# HISTORIC AND DESIGN REVIEW COMMISSION

March 06, 2024

**HDRC CASE NO:** 2024-053  
**ADDRESS:** 515 VILLITA ST  
**LEGAL DESCRIPTION:** NCB 142 BLK LOT 11  
**ZONING:** D, H, RIO-3  
**CITY COUNCIL DIST.:** 1  
**DISTRICT:** La Villita Historic District  
**APPLICANT:** Samuel Panchevre/Alamo City Investments  
**OWNER:** San Antonio Conservation Society Panchevre/Casa Catrina  
**TYPE OF WORK:** Construction of a terrace on the river side, installation of vinyl graphics, painting of murals, installation of an altar within flower bed  
**APPLICATION RECEIVED:** January 24, 2024  
**60-DAY REVIEW:** March 24, 2024  
**CASE MANAGER:** Edward Hall

### Upper Gazebo

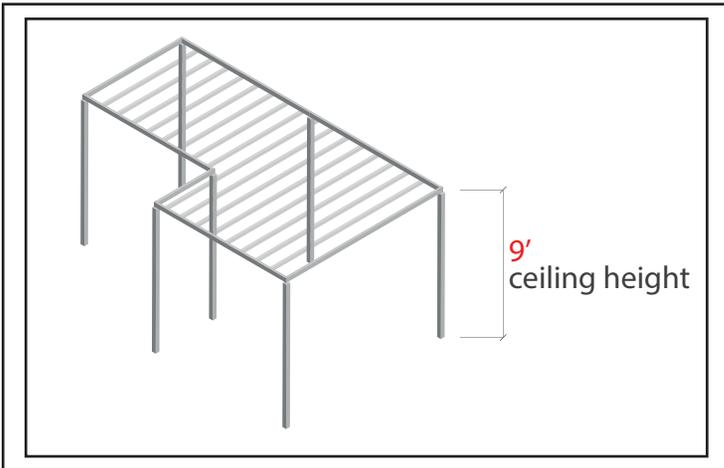
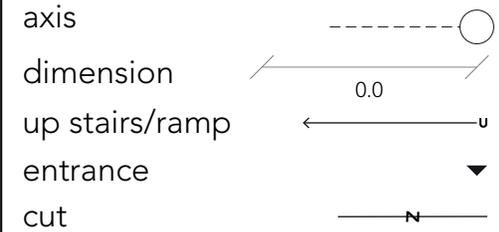
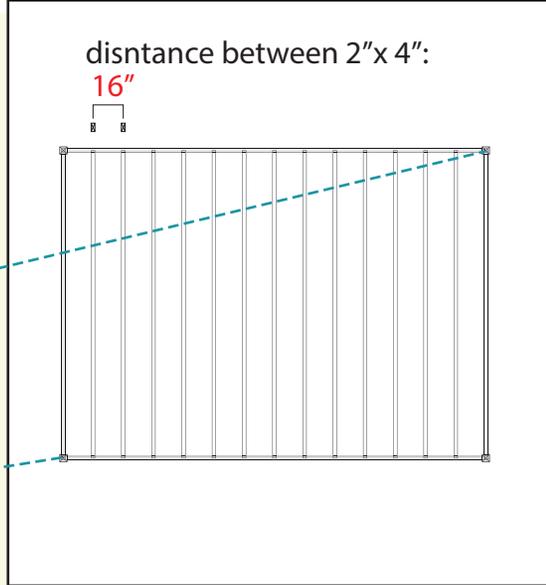
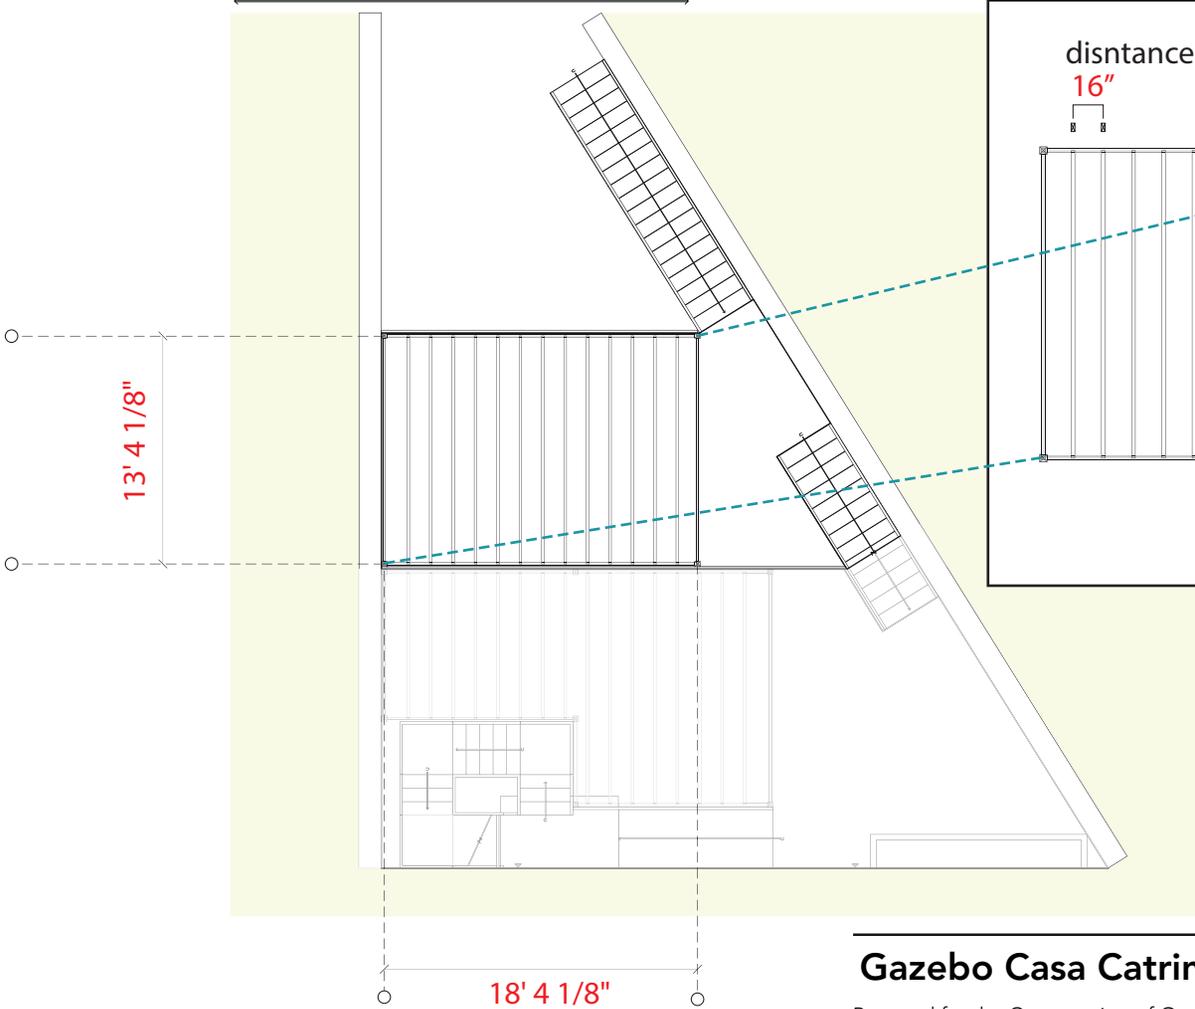
- c. TRELLISES – The applicant has proposed to construct a series of metal trellis structures to provide cover and shade for the terraced seating area on the river side of the property. The applicant has proposed for the trellises to be constructed of metal, featuring 4x4 metal columns with both metal perimeter beams and wood interior beams, and to be painted gray. The applicant has noted that the trellis structures will feature varying heights of eight (8) to nine (9) feet. The applicant has noted that the design will accommodate a water feature; however, the applicant has not provided additional information on this. Generally, staff finds the proposed trellis structure to be appropriate. All elements should be painted to complement the existing tones and colors found historically on site. The installation of the proposed trellis structures should not result in rainwater draining onto the public pathway at the River Walk.

- 1. Staff recommends approval of item #1, the construction of a series of metal trellises based on finding c, with the following stipulations:
  - i. That the trellises be painted to complement the existing tones and colors found historically on site.
  - ii. The installation of the proposed trellis structures should not result in rainwater draining onto the public pathway at the River Walk.
- 2. Staff recommends approval of item #2, the installation of vinyl graphics based on finding d.
- 3. Staff recommends approval of item #3, painted murals beneath the street and second level porches/balconies based on finding e.
